Attachment 8 – Shellharbour Development Control Plan 2013 Compliance Table

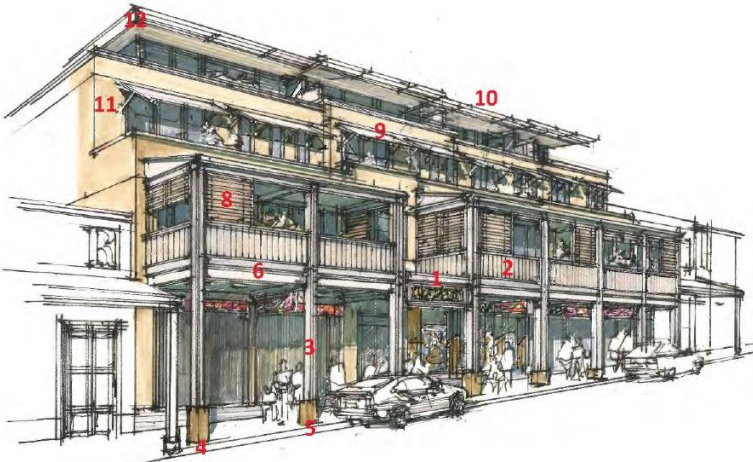
| CHAPTER 6 – COMMERCIAL DEVELOPMENT | | | |
|--|---|---|-----------------------|
| 6.1.38 | <p>Future possible building envelope provisions are as mapped in the relevant town centre plan endorsed by Council for individual centres. See Council's website. These are not mandatory as they rely on multiple lots being available to form all or part of a building envelope. Key development principles underpinning the future possible building envelopes are as follows:</p> <p>a. Solar access is optimised through ensuring appropriate building separation and north facing buildings whilst maintaining good building frontage onto streets based on State Environmental Planning Policy 65 Design Quality of</p> | <p>The subject site is located within Shellharbour Village. The Shellharbour Town Centre Plan was endorsed by Council on 18 March 2014. The Centre Plan provides guidance on how the area could be transformed into a successful town centre and using the development standards in the Shellharbour Local Environmental Plan 2013.</p> <p>The Town Centre Plan does not detail a future possible building envelope on the subject site (shown in extract below).</p> | N/A |

| CHAPTER 6 – COMMERCIAL DEVELOPMENT | | | |
|--|--|--|------------|
| <p>Residential Apartment Development (SEPP 65) and its associated Apartment Design Guide.</p> <p>b. All concept building blocks are designed to optimise thermal performance, thermal comfort, and daylighting to improve a buildings energy efficiency.</p> <p>c. All concept building blocks should ensure visual privacy and acoustic privacy through adopting SEPP 65 design principles.</p> <p>d. Crime Prevention Through Environmental Design (CPTED) principles. See separate chapter in this DCP.</p> | |  <p>Figure 6.04 - Form and Footprint Plan</p> <p>Extract of Figure 6.04 Form and Footprint Plan from the Shellharbour Village Centre Plan (March 2014). The subject site is outlined in green.</p> | |
